To: T10 Technical Committee
 From: Rob Elliott, HP (elliott@hp.com)
 Date: 7 May 2007
 Subject: 07-090r1 SAS-2 Transmit IDENTIFY three times

Figure 3 — SL_IR (link layer identification and hard reset) state machines

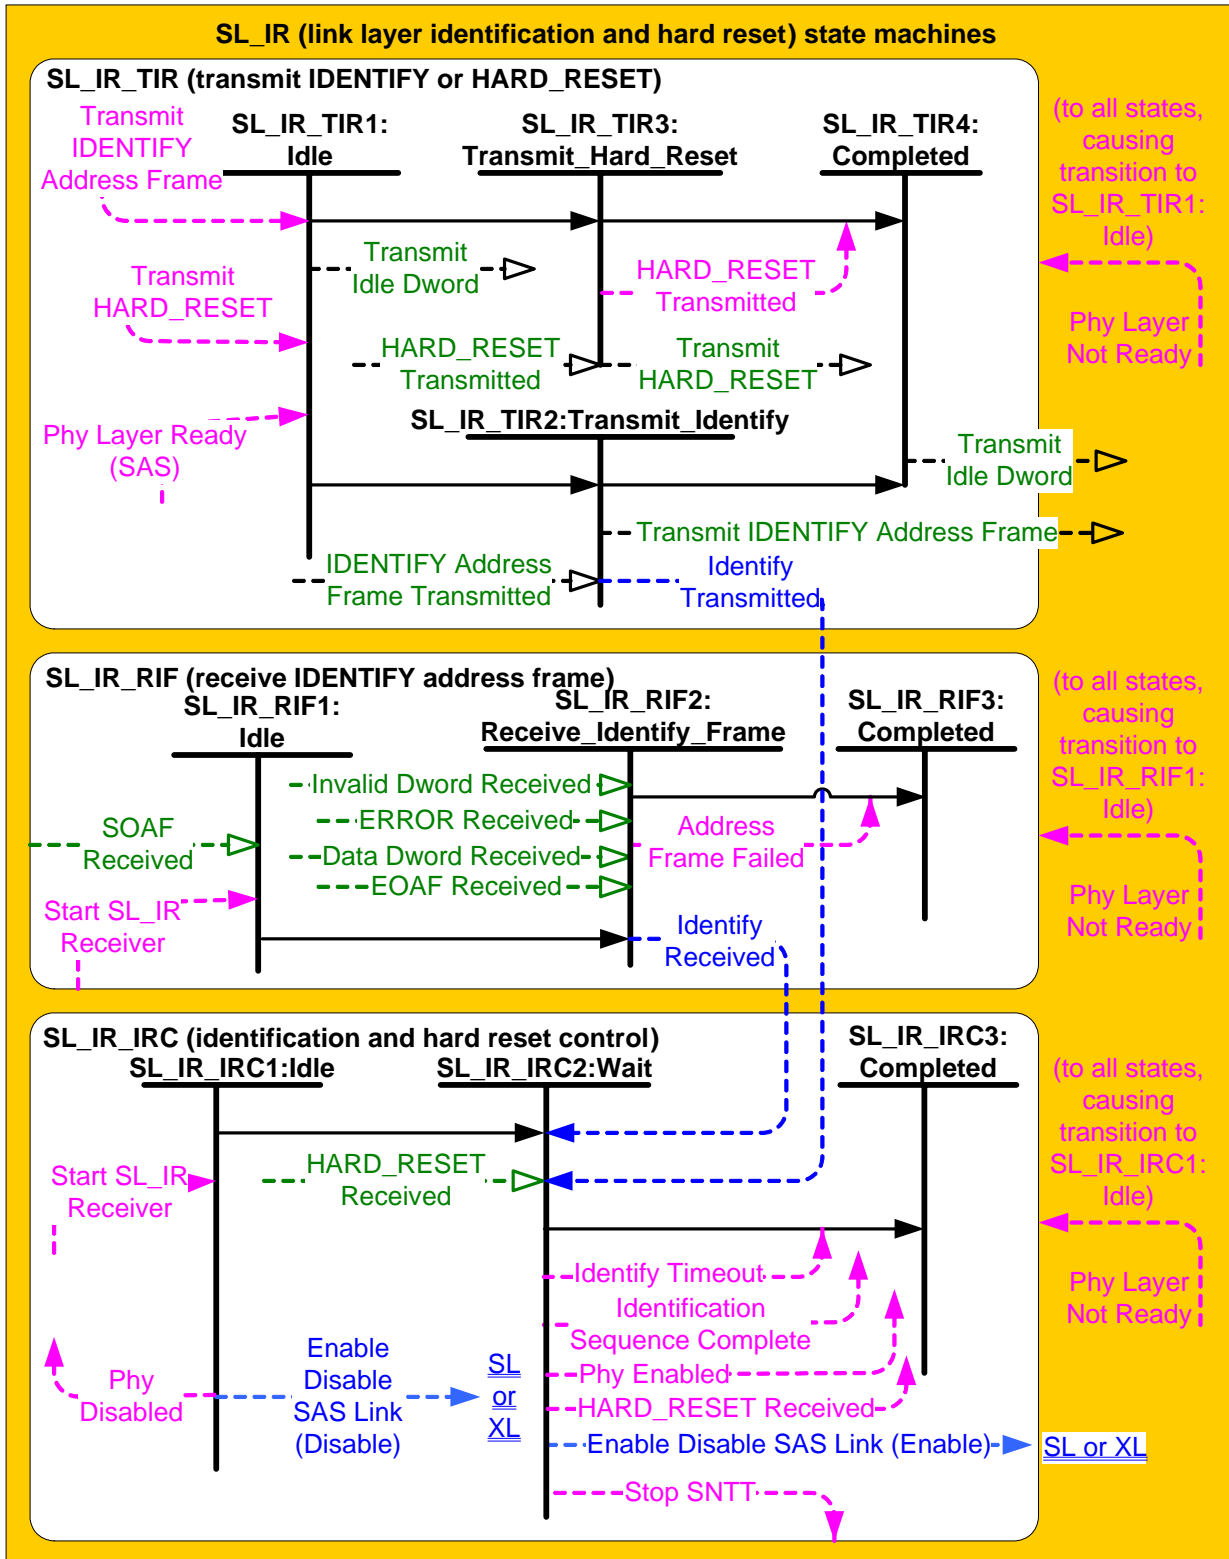
The SL_IR_TIR state machine's function is to transmit ~~a single IDENTIFY address frame~~ one or three IDENTIFY address frames or a HARD_RESET primitive after the phy layer enables the link layer. This state machine consists of the following states:

Upon entry into this state, this state shall send ~~a~~either one or three Transmit IDENTIFY Address Frame messages to the SL_IR transmitter.

If this state receives an SOAF Received message, then this state shall ~~discard the address frame (i.e., the subsequent Data Dword Received and EOAF Received messages) and discard any previously received dwords for the address frame.~~ send an Address Frame Failed confirmation to the management application layer to indicate that an invalid IDENTIFY address frame was received, and start receiving the new address frame.

This transition shall occur after sending an Identify Received message ~~or Address Frame Failed~~ confirmation.
